From:	/O=CITY OF RANCHO PALOS VERDES/OU=EXCHANGE ADMINISTRATIVE GROUP (FYDIBOHF23SPDLT)/CN=RECIPIENTS/CN=0032A7869B1F4D7BB8F8A69AE1B44
To:	Selim <Selim@sawayaeng.com>
Cc:	Ara Mihranian; So Kim; Ron Dragoo; Jill Martin <jmartin@trumpnational.com>
BCc:	Doug Willmore; Elias Sassoon
Subject:	RE: Tract 50666
Attachments:	2018-06-19 No Rt-Turn+Merge Lane.pdf

TRACT 50666

PVDS INTERSECTION EXHIBIT

PALOS VERDES DRIVE SOUTH & COSTA DE LA ISLAS
WITH NO RIGHT TURN TO DEVELOPMENT

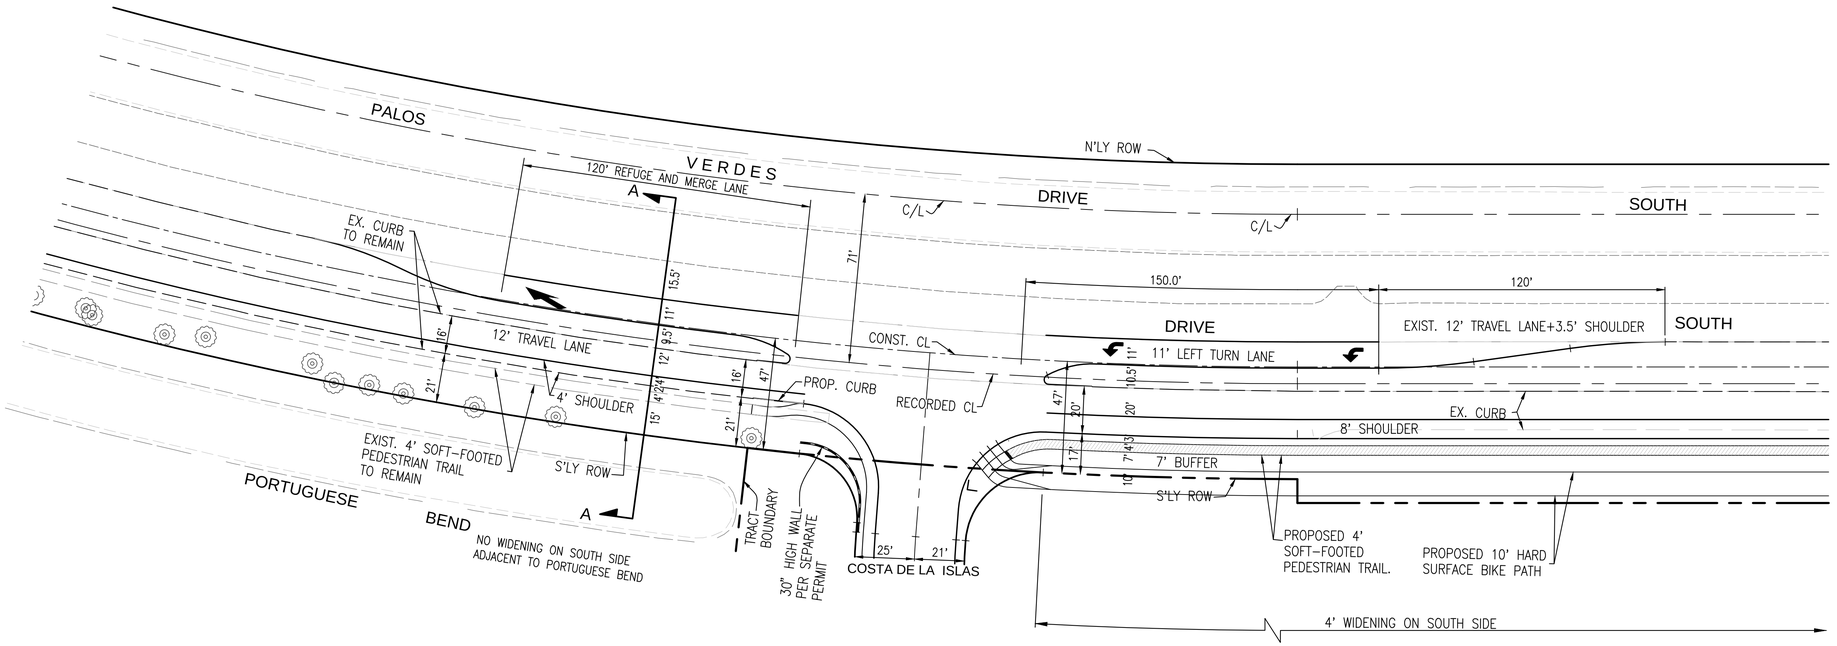
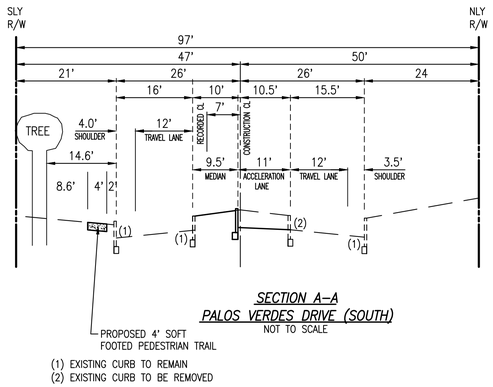
1-we would like the 10' wide Hard Surface Bike Path to be of concrete.
2-Please indicate where this bike path goes to and if terminates where and how?
3-Pls show a cross section across PVDS to the east of Costa De La Islas.
4-Please extend the 30-inch wall to capture the light beams from the vehicular traffic turning onto Costa De La Islas
5-Please show the type of proposed landscaping within 3' and 7' buffer.

Thank you for your e-mail. We are currently preparing the final engineering plans for PVDS based on the attached exhibit and your recommendation to the City Council to eliminate the right turn lane into the development. We will not have a bike lane adjacent to / in front of the Portuguese Bend Club. The 8' bike lane will start at Costa De Las Islas going east to join the bike lane at Trump National drive.
